OUTLINE OF NEW FEATURES

The following changes have been made for the new HIACE.

▶ The 1TR-FE Engine Models for Hong Kong Package ◀

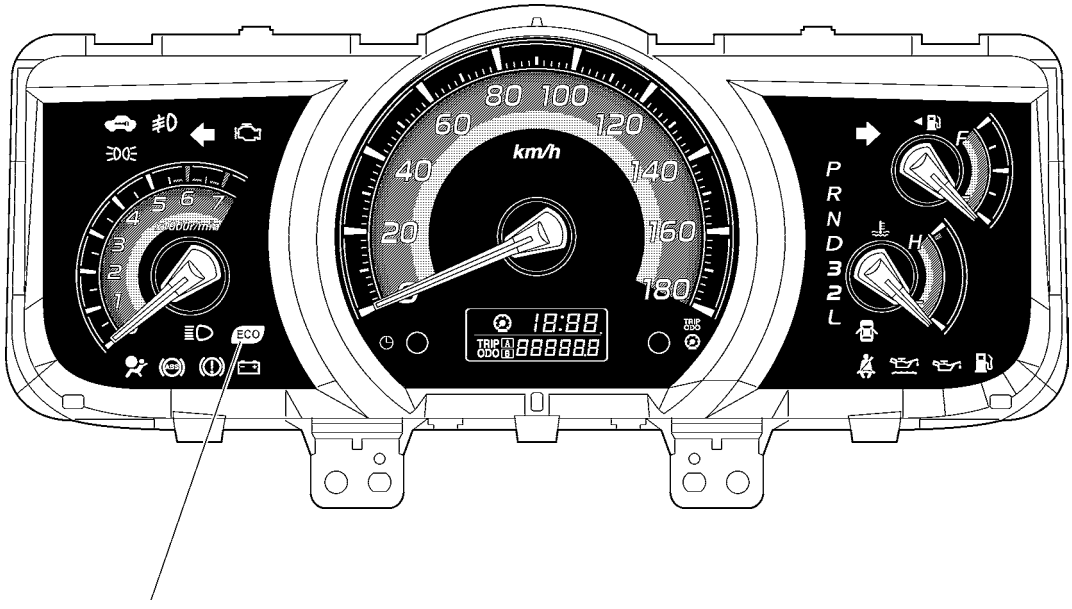
- A DPF indicator light has been provided for the 1KD-FTV engine equipped Chile package models.
- For the 1KD-FTV engine equipped Chile package models, the water temperature threshold value that is used for one of the conditions to turn on the engine oil lower level warning light has been increased from 55°C to 60°C.
- For the 1KD-FTV engine equipped Chile package models, a part of the system has been changed, including the change of the target to which the oil pressure terminal connected from the engine oil pressure switch assembly to the ECM.
- The Eco Driving Indicator Light has been adopted to the combination meter assembly of the 1TR-FE engine models for Hong Kong package. For details, see page 93.

▶ System Diagram ◀

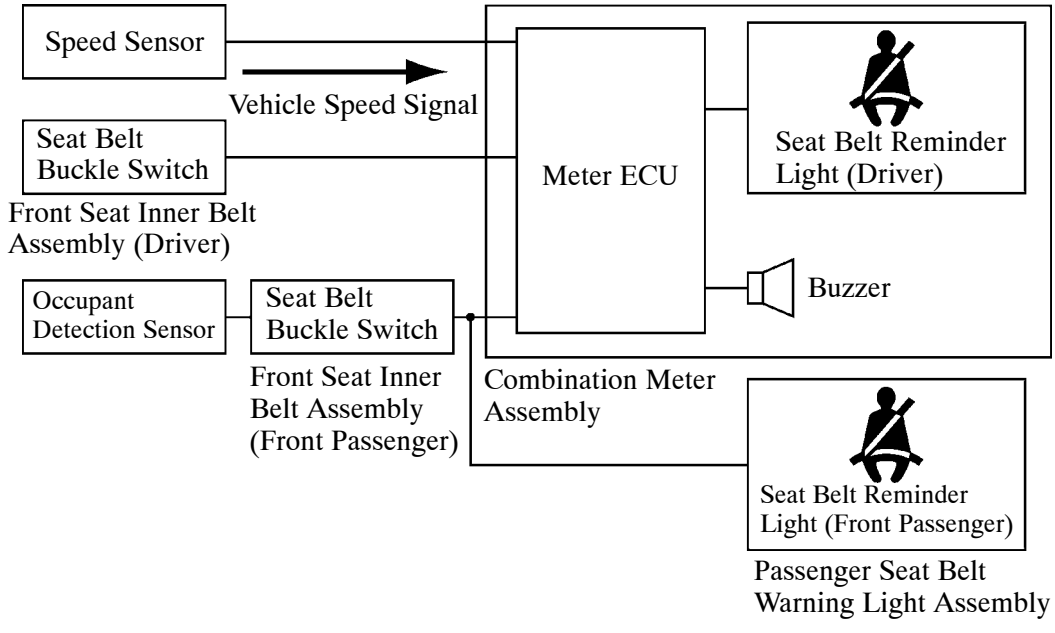
- The seat belt reminder system (buzzer and light) only for driver seat has been provided as standard equipment of the 1TR-FE engine models for Hong Kong package.
- The seat belt reminder system (buzzer and light) for driver seat and front passenger seat has been provided as optional equipment of the 1TR-FE engine models for Hong Kong package.
